## WSR 23-15-015

## EXPEDITED RULES

Purpose of the Proposal and Its Anticipated Effects, Including Any Changes in Existing Rules: Reconciling state amendments with section renumbering and model code modifications in the 2021 IRC; correcting errors and omissions.

Figure R403.1.1(1)  
 Alternative Minimum Footing Size for Light-Frame Construction  
 a, b, c, d, e, f, g, h, i  
 20 PSF Snow Load

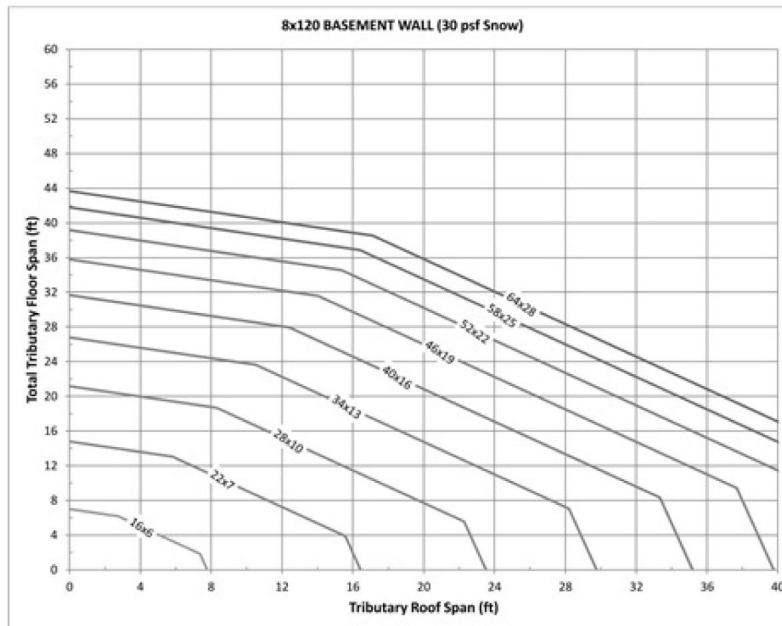
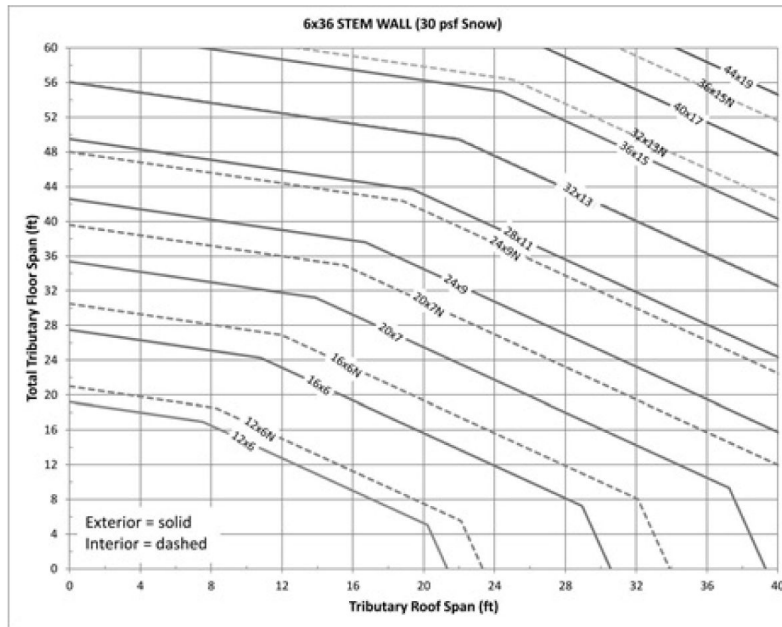
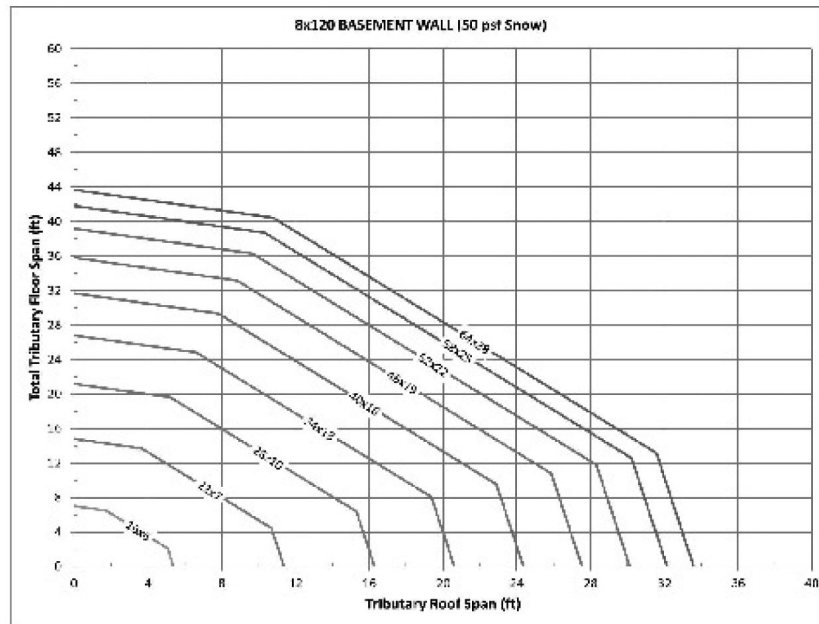
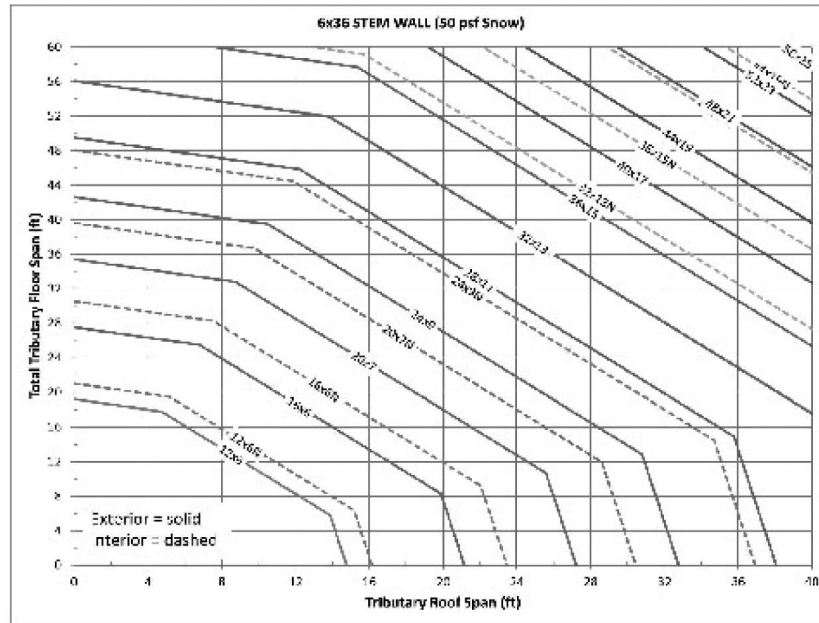
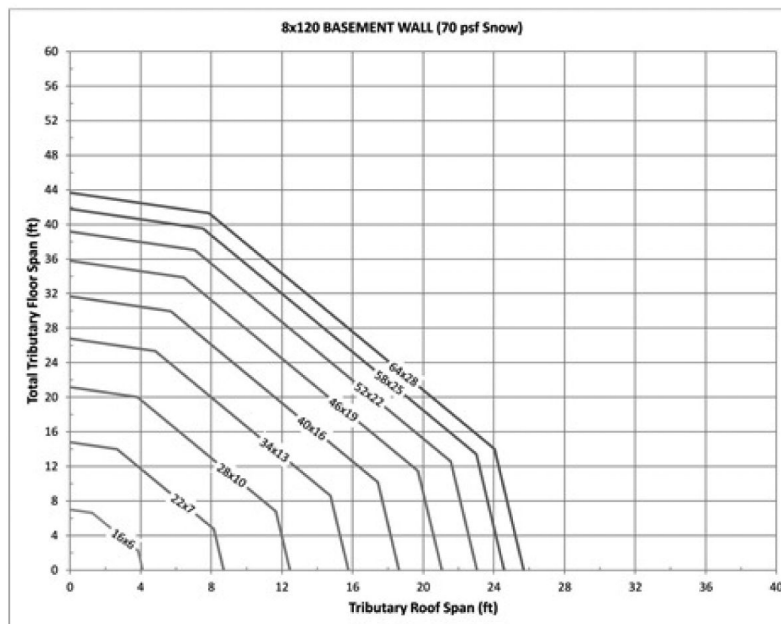
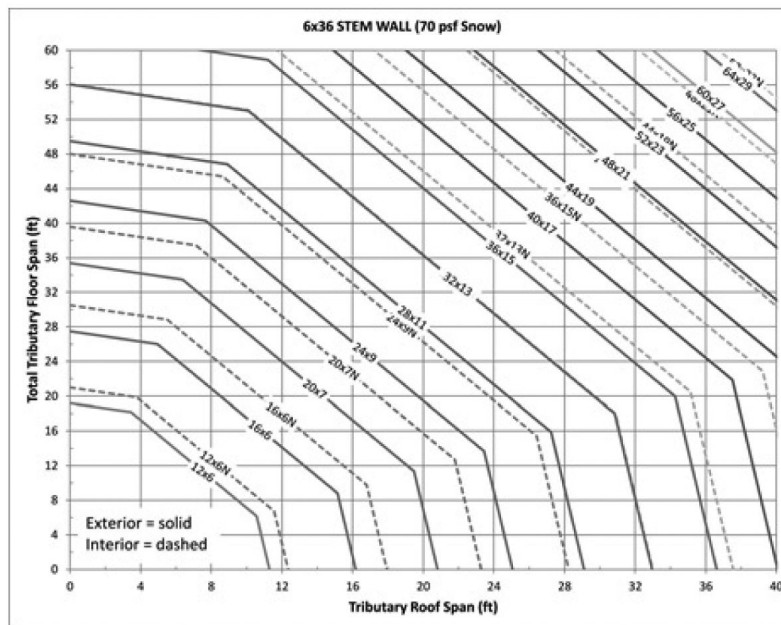
WAC	Section	Change	Rationale/Discussion
51-51-0403	Figure R403.1.1 (1), R403.1.1 (2), R403.1.1 (3), R403.1.1 (4) footnote c.	Spells out feet.	Editorial modifications with no change in regulatory effect; intended to align the state amendment with the model code language.
51-51-0408	R408.1	Replaces the word "six" with the number "6" and adds a metric measurement (152 mm) for six inches.	Editorial modifications with no change in regulatory effect; intended to align the state amendment with the model code language.
	R408.1 Exception	Replaces the word "two" with the number "2" and adds a metric measurement (51 mm) for two inches.	
51-51-0507	Table 507.3.1	<ul style="list-style-type: none"> <li>Identifying the applicable cells for the footnotes.</li> <li>Editorial modifications.</li> </ul>	Editorial modifications with no change in regulatory effect; intended to align the state amendment with the model code language.

- b Use tributary span of floor and roof. Figure may be used to size exterior and interior footings.
  - c Add 4 feet to tributary floor span for each wood-framed wall above first level (i.e., ((4')) 4 feet for 2-story, ((8')) 8 feet for 3-story).

- b Use tributary span of floor and roof. Figure may be used to size exterior and interior footings.
  - c Add 4 feet to tributary floor span for each wood-framed wall above first level (i.e., ((4')) 4 feet for 2-story, ((8')) 8 feet for 3-story).

- b Use tributary span of floor and roof. Figure may be used to size exterior and interior footings.
  - c Add 4 feet to tributary floor span for each wood-framed wall above first level (i.e., ((4')) 4 feet for 2-story, ((8')) 8 feet for 3-story).

- b Use tributary span of floor and roof. Figure may be used to size exterior and interior footings.
  - c Add 4 feet to tributary floor span for each wood-framed wall above first level (i.e., ((4')) 4 feet for 2-story, ((8')) 8 feet for 3-story).
